THE VIEWS PLANNED DEVELOPMENT

20-028 SUB/TREE/FSH/PD: The Views

M E M O R A N D U M

Future Street Layout

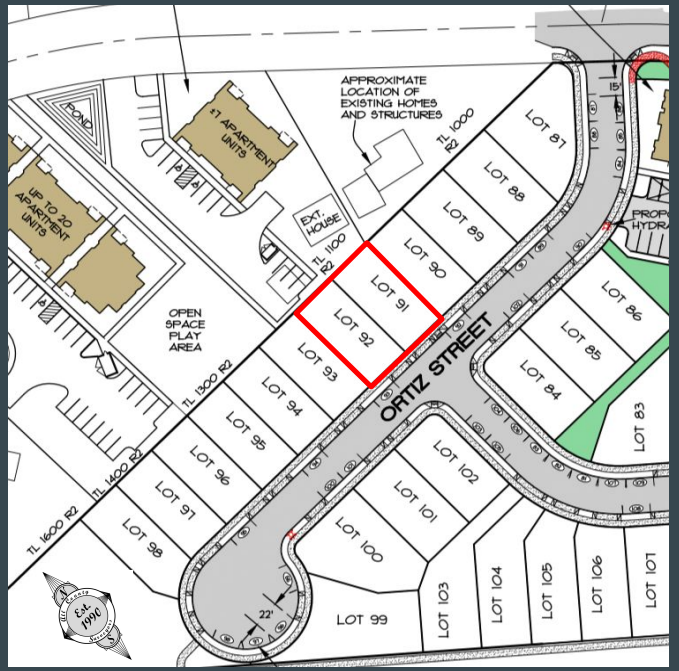
- Staff recommends street stub for Knapp Street or pedestrian connection through Lots 91 and 92 to create connectivity for future development.

Special Variances

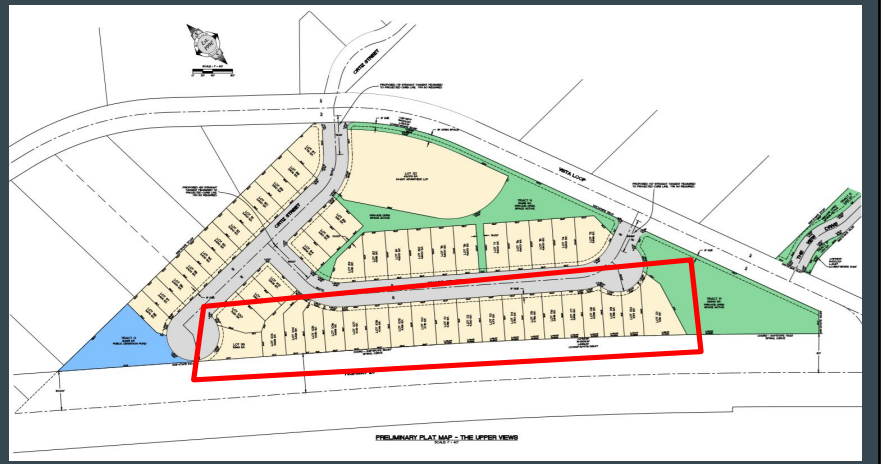
- SDC Section 17.82.20 says that homes abutting a transit street must face the transit street.
- Lots 99 and 103-121 in The Upper Views abut Highway 26
- Applicant is requesting that these homes face the internal streets.

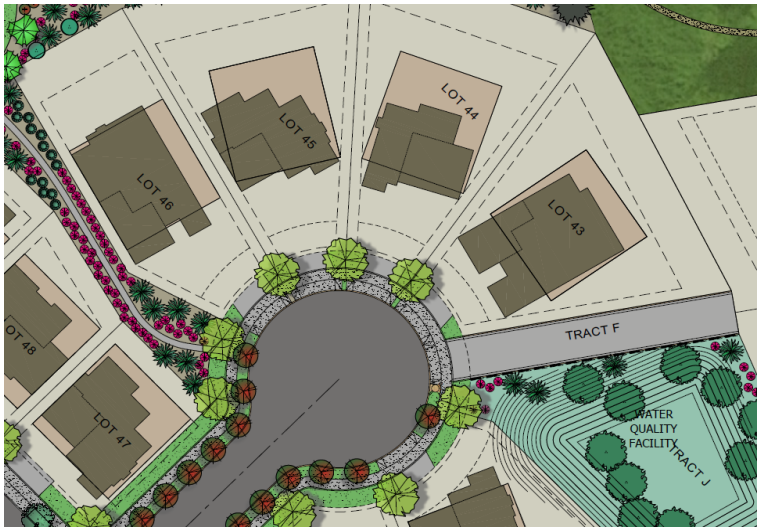
Per Section 17.98.100(G), the sum of the width of all driveway approaches within the build of a cul-de-sac as measure in Section 17.98.100(B) shall not exceed fifty percent of the circumference of the cul-de-sac bulb. The applicant submitted additional analysis (Exhibit _) showing that cul-de-sacs in the development comply with this standard. This requirement is satisfied.

Response: *The applicant requests this Condition be modified to allow lots accessed from a cul-de-sac to have their own driveway rather than a shared driveway. The reason for this request is these are the premium lots in the development, likely to contain three car garages and RV parking. A shared driveway configuration makes maneuvering in and out of these lots more challenging and detracts from the benefit of having a large lot. As shown on the sketch below, the proposal for individual driveways provides an opportunity to plant three trees within the cul-de-sac. In addition, as the attachment below shows, the sum of the width of all driveway approaches in the two proposed cul-de-sacs do not exceed 50 percent as required.*
